# Condensation risk on outer wall above RSJ?

# Joist very close to RSJ/Wall – where to put insulation and air tightness membrane?

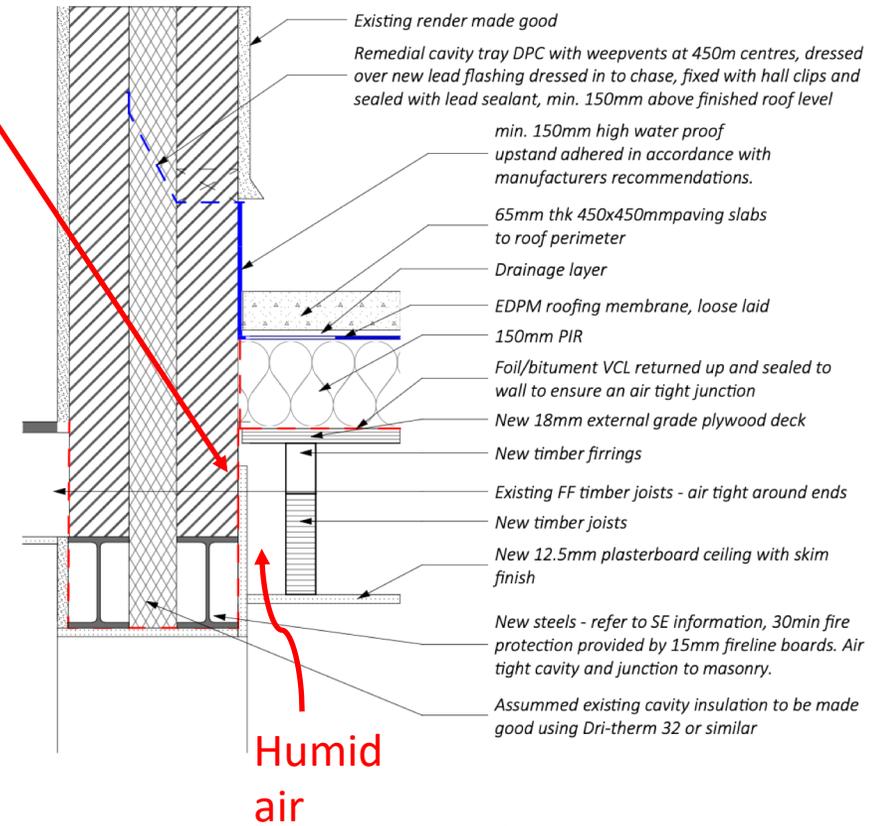
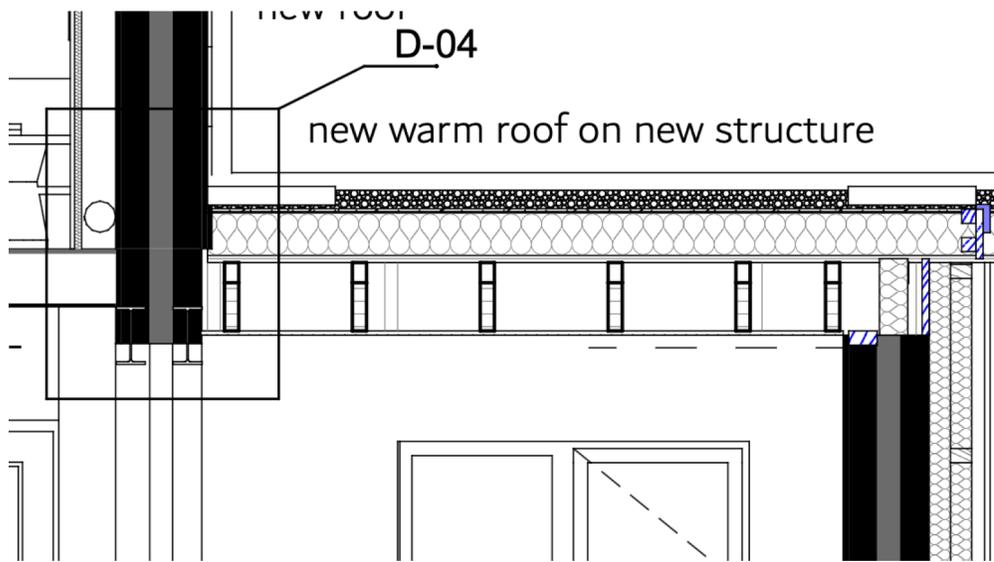
Significant condensation risk on cold outer wall above RSJ

D-04

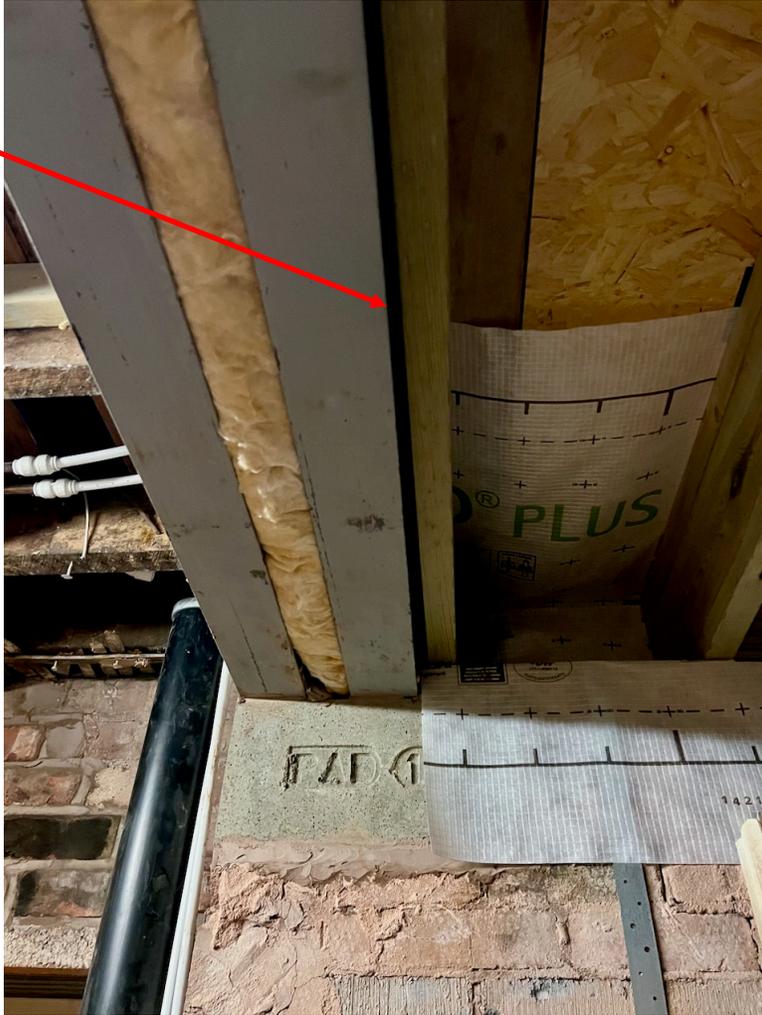
Builder wants to put joist close to wall to support above roof junction

Currently no insulation or airtightness on this junction

The builder said he can unscrew the joist if we tell him what to do.

Q: Should I try to move the joist a little and add breathable insulation between joist and wall?

Q: Should I try to close the gap to prevent any humid air to go in?
